SUBJECT: Class II Permissive change

Description of permissive changed parts

FCC ID: MMAT295

Saw filter change to LC filter

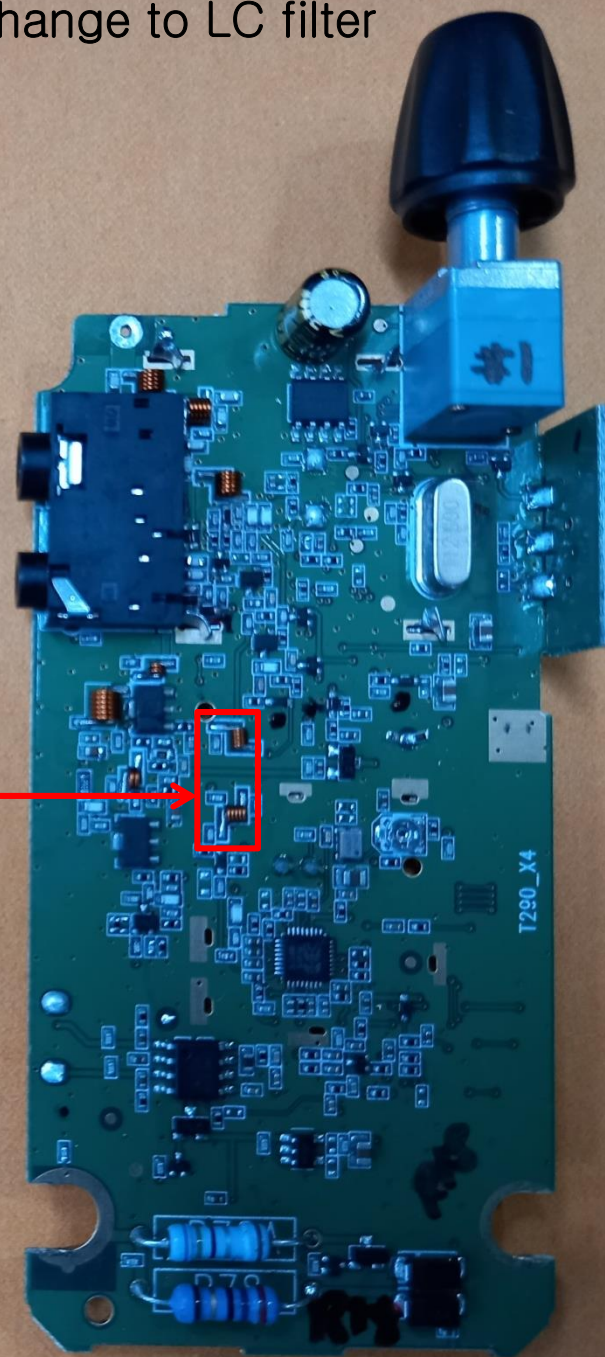
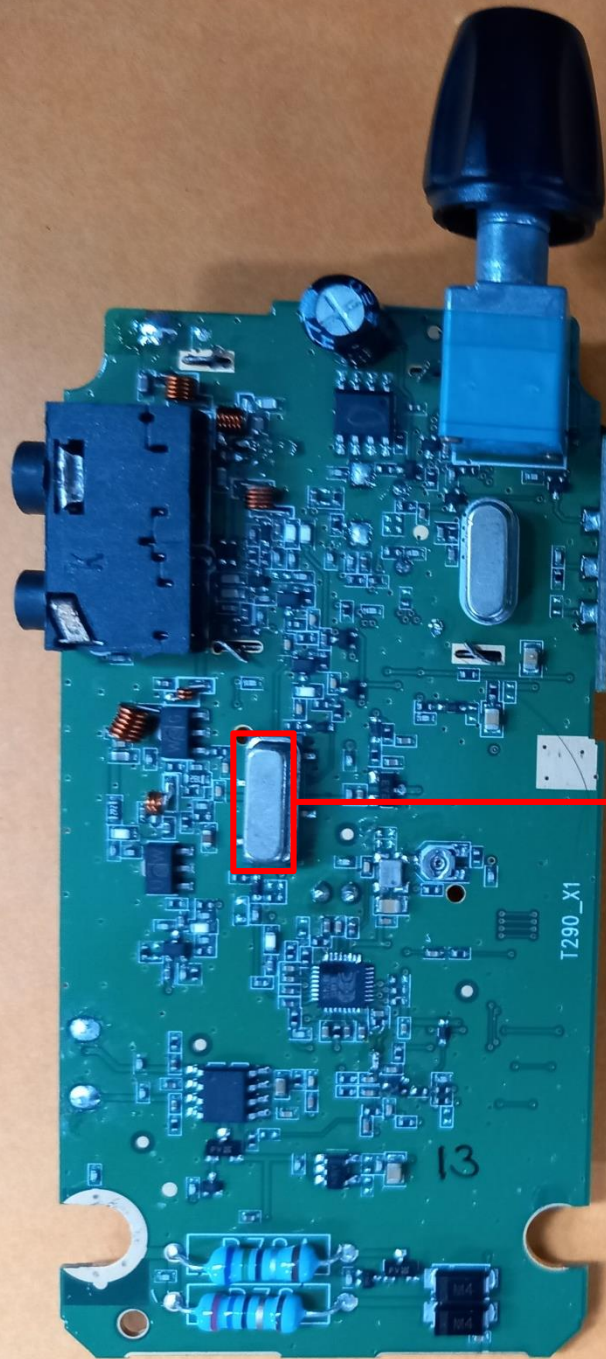
- 1) SF1(FTF465BS) of Saw filter change to X4 LC filter(C38, C72, C75, C89, L5, L16)
- 2) IC6(GT809118) of Animal tone IC change to NY4B018C

Animal tone IC change
